BEFORE THE
UNITED STATES NUCLEAR REGULATORY COMMISSION

DOCKET NO. 50-416

SUBJECT: Offsite Organization, Technical Specification Figure 6.2.1-1,
page 6-3

FIGURE 6.2.1-1 OFFSITE ORGANIZATION

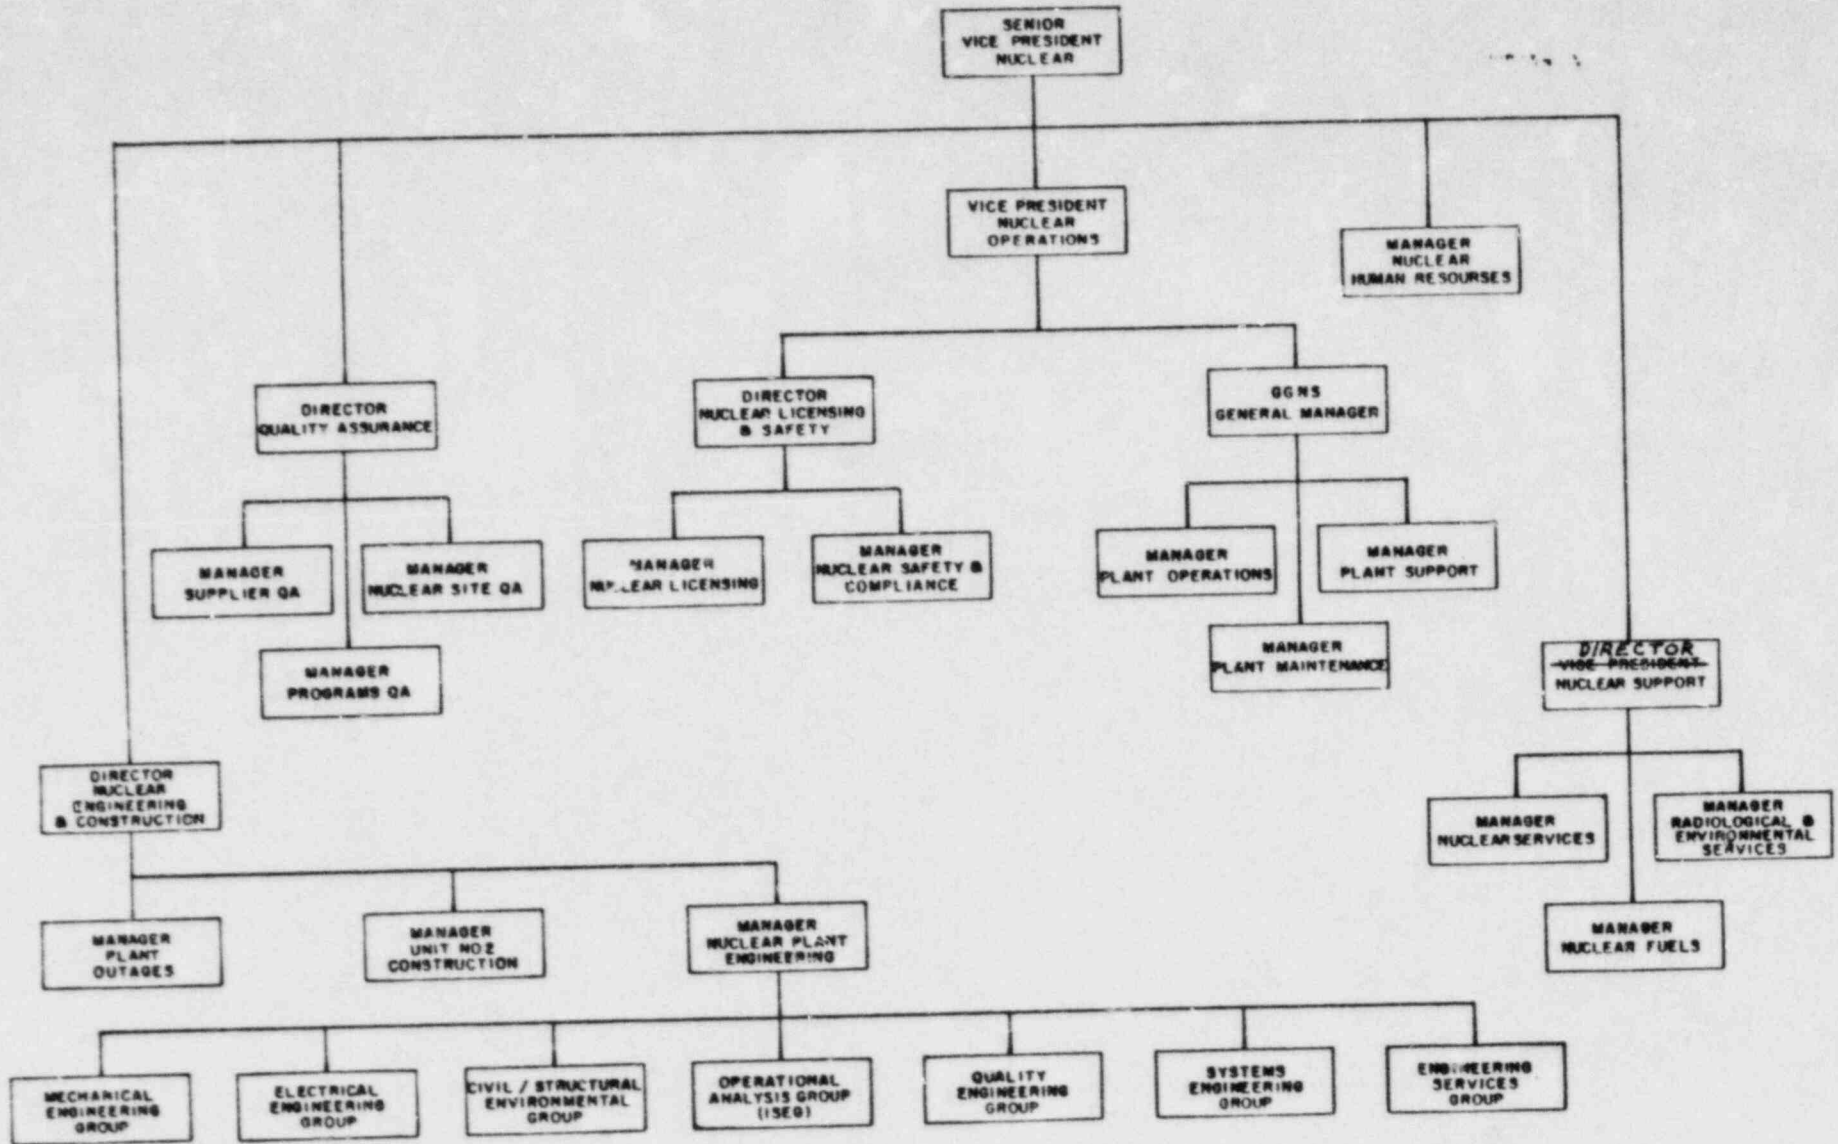
DESCRIPTION OF CHANGE: Revision of technical specification figure 6.2.1-1 is proposed to reflect a recent change of position title in the Nuclear Production Department. The position of Vice President, Nuclear Support has been changed to Director, Nuclear Support.

JUSTIFICATION: The proposed change will make the technical specifications consistent with the personnel policies of MP&L's Nuclear Production Department. The responsibilities of and qualifications for the position affected are equivalent to those of the other directors' positions in the department. This change will not affect the function of this position or alter the lines of communication or responsibility, but is a change of title only.
